City of Grain Valley, Missouri
FRONT STREET ROADWAY, STORM & WATER IMPROVEMENTS
November 26, 2024
Addendum No. 2

DOWNTOWN IMPROVEMENTS PHASE II-B
FRONT STREET
GRAIN VALLEY, MISSOURI

STREET, STORM & WATER IMPROVEMENTS
TYPICAL SECTIONS
AND GENERAL NOTES

Addendum 2 11/26/2024

DRAWING NO. 2 OF 29

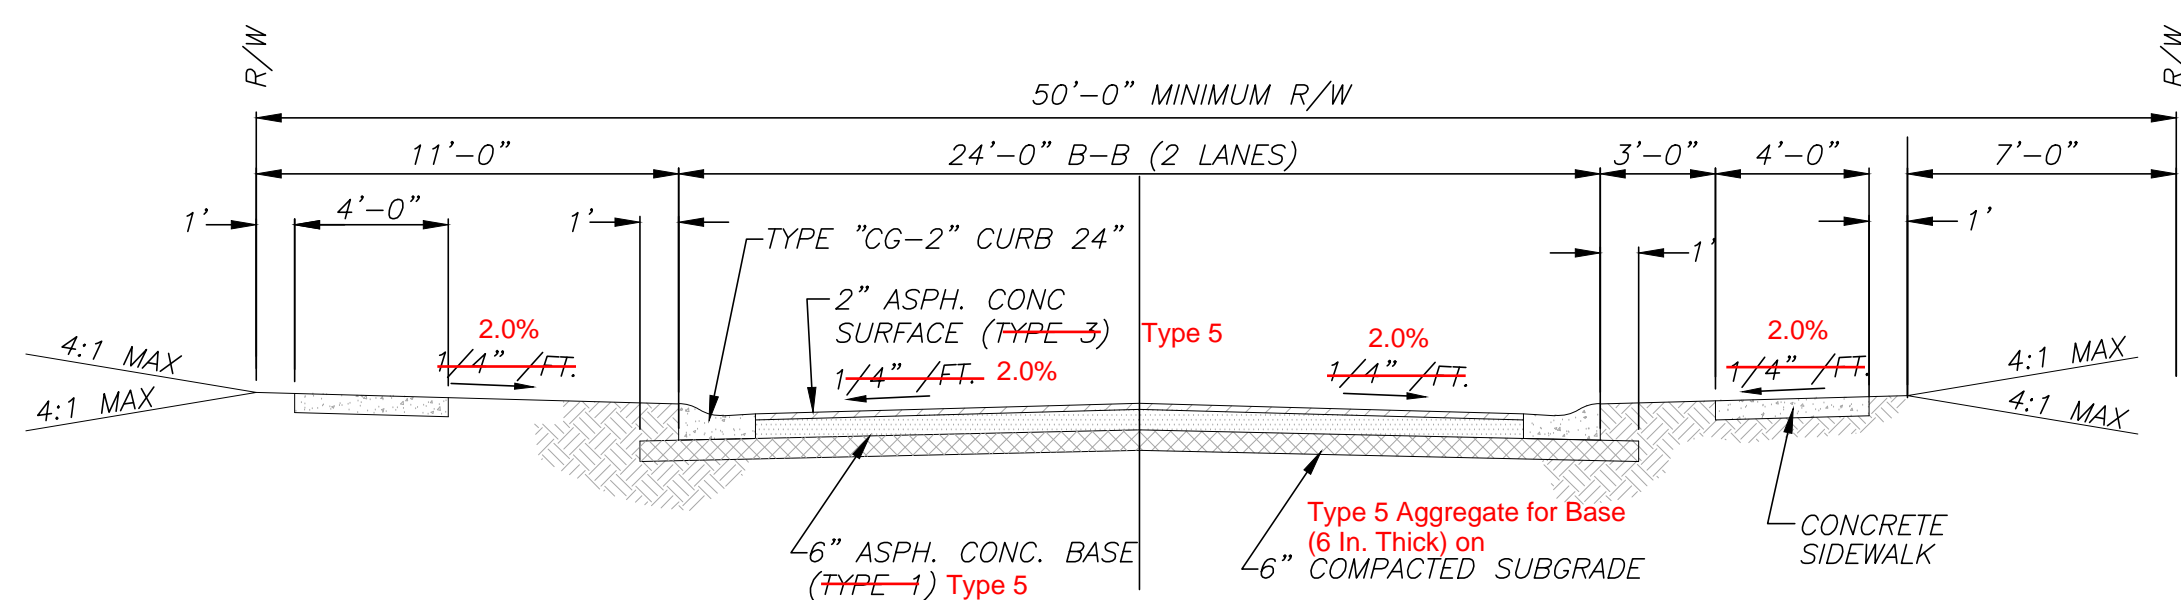
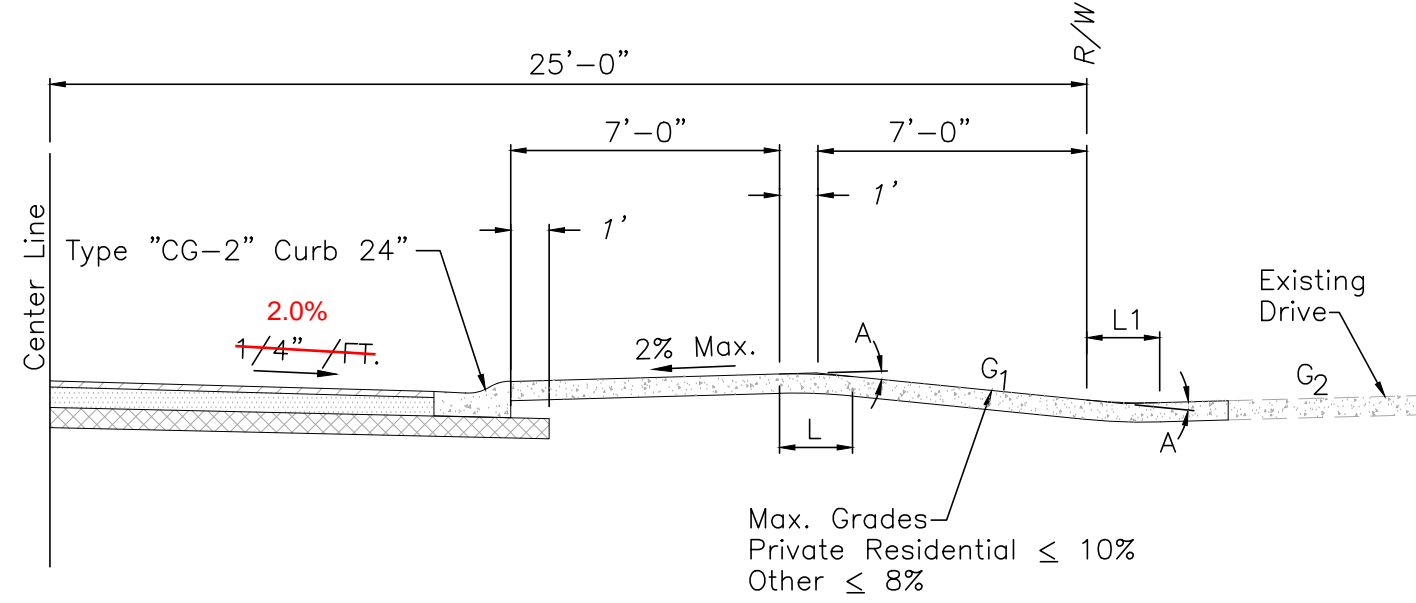
- Excess millings shall be hauled and dumped at ~~Old~~ US-40 Highway Football fields as per City instructions. the Parks Maintenance area on Buckner Tarsney Road
- All street construction on this project to be performed in accordance with City of Grain Valley and APWA Standard Specifications.
- Wheelchair (Handicap) ramps shall be required at all intersections.
- City may require testing of concrete or asphalt material. Cost of testing to be incurred by the contractor.
- City to be notified 24 hours prior to sampling for proctor testing and/ or compaction testing. The City retains the right to halt construction for failing to be made aware of testing.
- All fill to be placed in maximum 12" lifts. All fill to be tested for compaction every 12", in accordance with APWA 2106.2.
- Follow MoDOT Specification 1050 for fencing and gates.
